**City of Bellevue
Development Services Department
Land Use Division Staff Report**

Proposal Name: **Sherwood Duplex**

Proposal Description: Request for Design Review approval to demolish an existing duplex and replace with a two-unit duplex within a Single-Family Transition Area Design District. A Variance is requested to modify building setbacks.

File Number: **12-127820-LD
12-127822-LS**

Proposed House Elevations

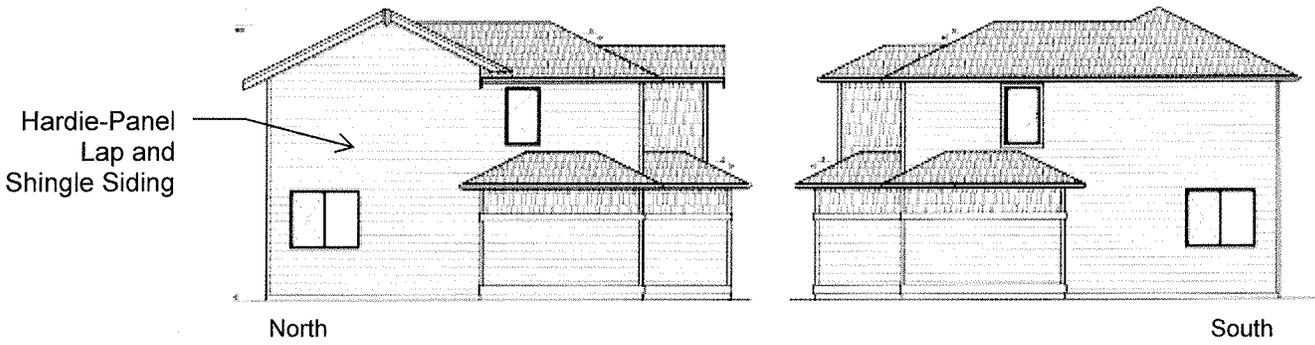
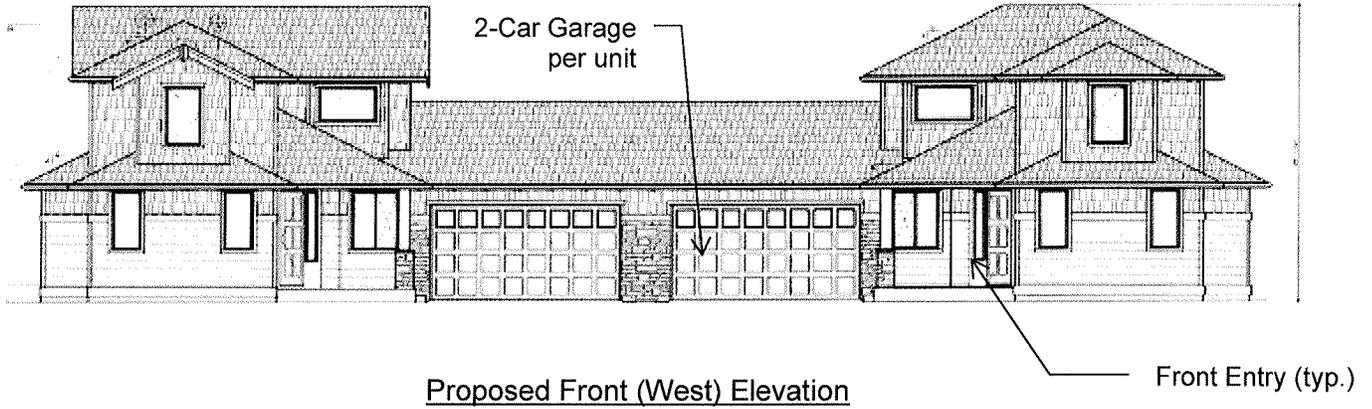
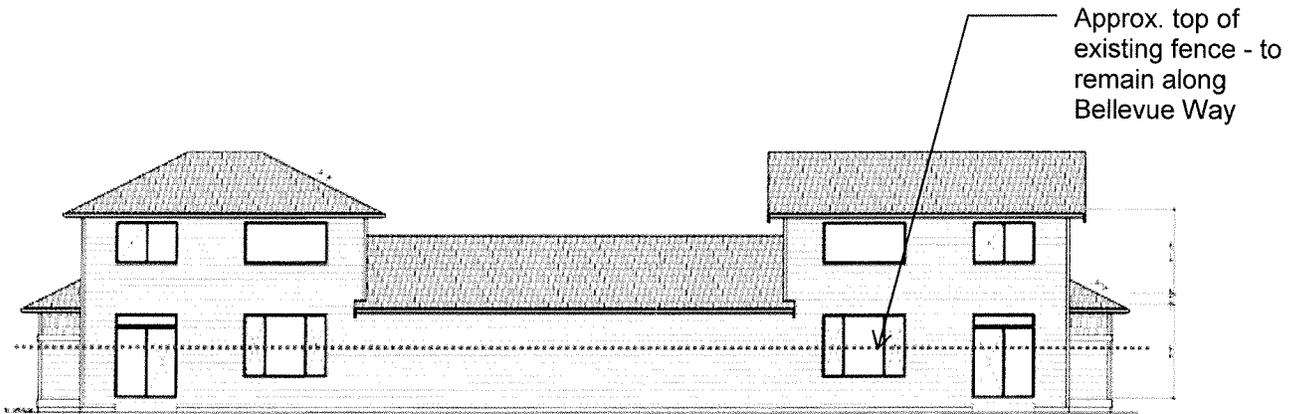
3. **Building Design Guidelines:** As conditioned, the proposed building design complies with the Building Design Guidelines (LUC 20.25B.050.B):
- a. **Exterior Cladding:** Proposed exterior cladding materials include horizontal HardiePlank and HardieShingle siding, stone accents, and asphalt composition roofing. All of the proposed materials and earth-tone colors are appropriate for a residential use and compatible with materials used in nearby residential development. A Condition of Approval will require additional case molding similar to that shown around the windows on the front (west) elevation of the duplex to be placed around the windows on the southern façade (facing 102nd Place NE) and around all second story windows facing Bellevue Way NE. This detail will add architectural interest and will be consistent with architectural detailing found on neighboring homes. **Refer to Condition of Approval regarding the exterior window casing on the eastern and southern facades in Section IX of this report.**

The applicant shall provide additional exterior window molding (trim), similar to that proposed on the west façade of the building, around the two windows on the southern façade (facing 102nd Place NE) and around the four second story windows on the eastern façade (facing Bellevue Way NE).

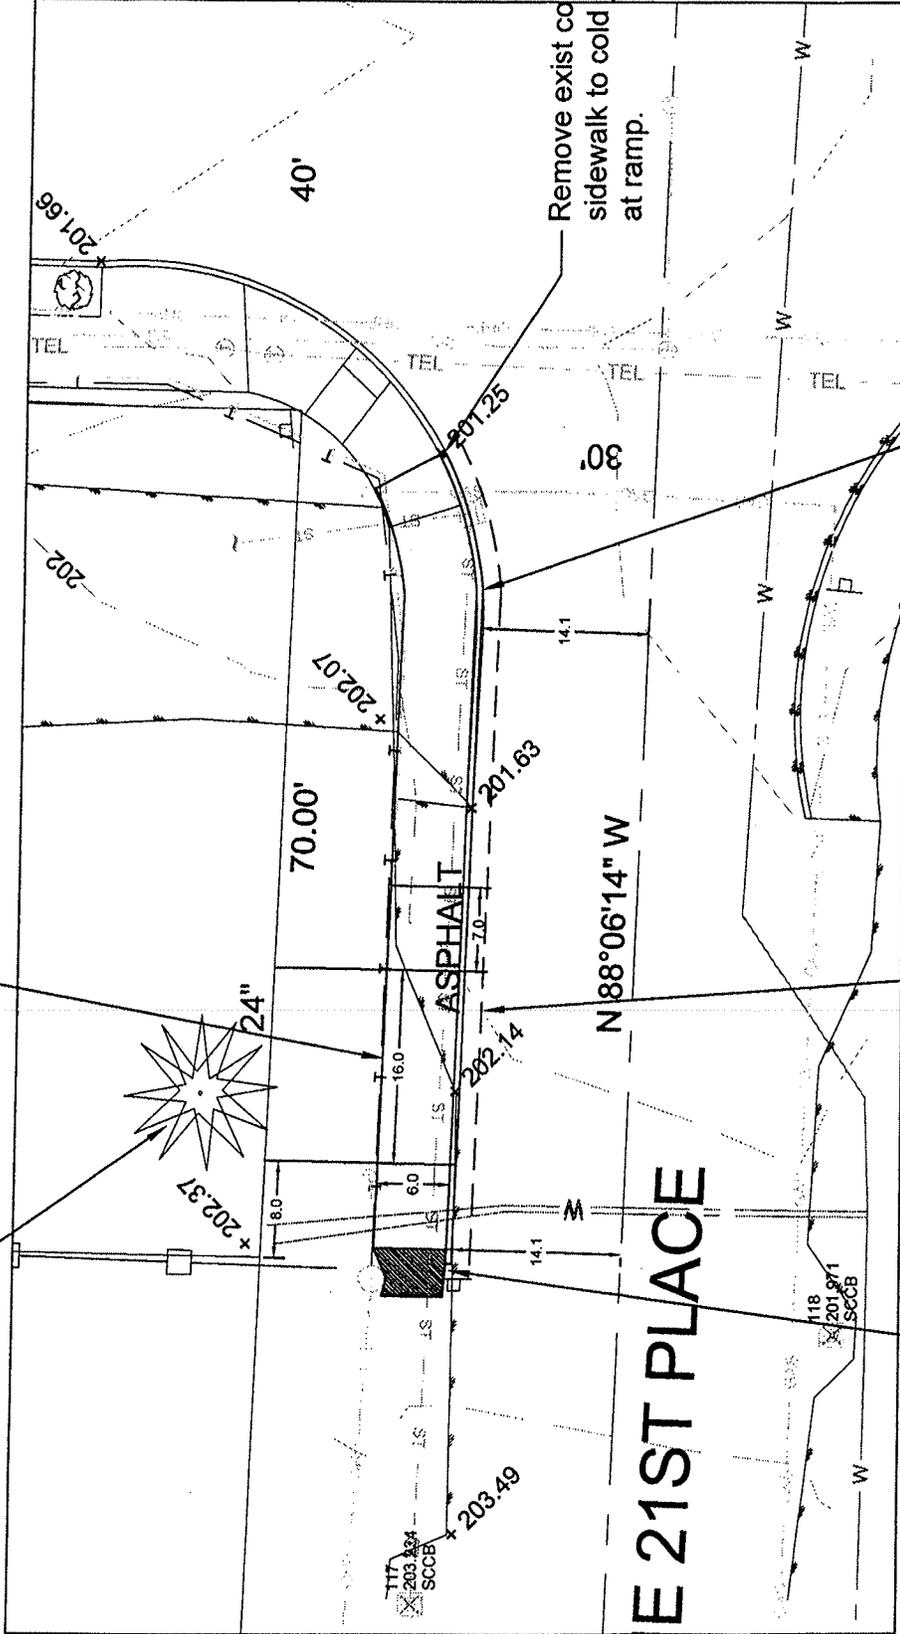
- c. **Significant vegetation retention:** All significant trees will be retained except for one existing tree within the front setback. The tree will be removed to accommodate the new driveway. The driveway must be moved west from its current location due to safety issues identified by the Transportation Department. The proposed landscaping meets the transition area requirements and will help soften the visual impact of the project on nearby residential uses. **Refer to Condition of Approval regarding the tree protection plan in Section IX of this report.**

Exist. tree to be removed.

Install Driveway Cut
per Std DEV-7A
